PCN

Change of packaging for HVC25 series

Enclosure PCN (ID No. PPD029/ T127)

1.	1. ID No. PPD029/ T127		2. Date of announcem	ent February 17, 2023
3.	Product / product group High-voltage contactors HVC25 series	Old ordering code See UPtoDATE	New ordering code No change	Customer part number NA

Comparison of old and new packaging

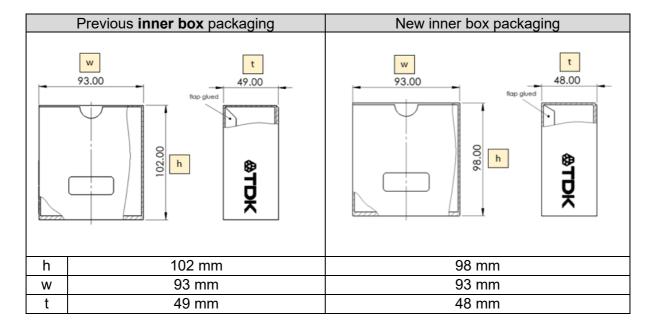
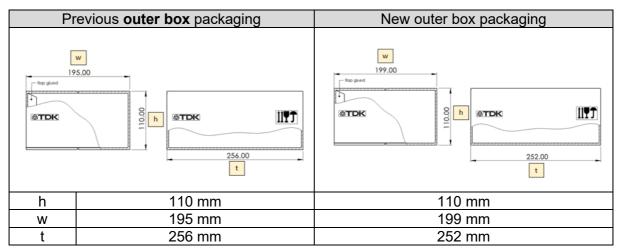
To reduce waste, the packaging for the HVC25 series of high-voltage contactors will be adapted. The dimensions of the outer and inner box change slightly and the paper space will be removed.

A new packaging of outer and inner box are being introduced for HVC25 series:

The paper space will be removed to reduce the waste.

Outer box packaging will be changed from h=110 mm x w=195 mm x t=256 mm to h=110 mm x w=199 mm x t=252 mm.

Inner box packaging will be changed from h=102 mm x w=93 mm x t=49 mm to h=98 mm x w=93 mm x t=48 mm.
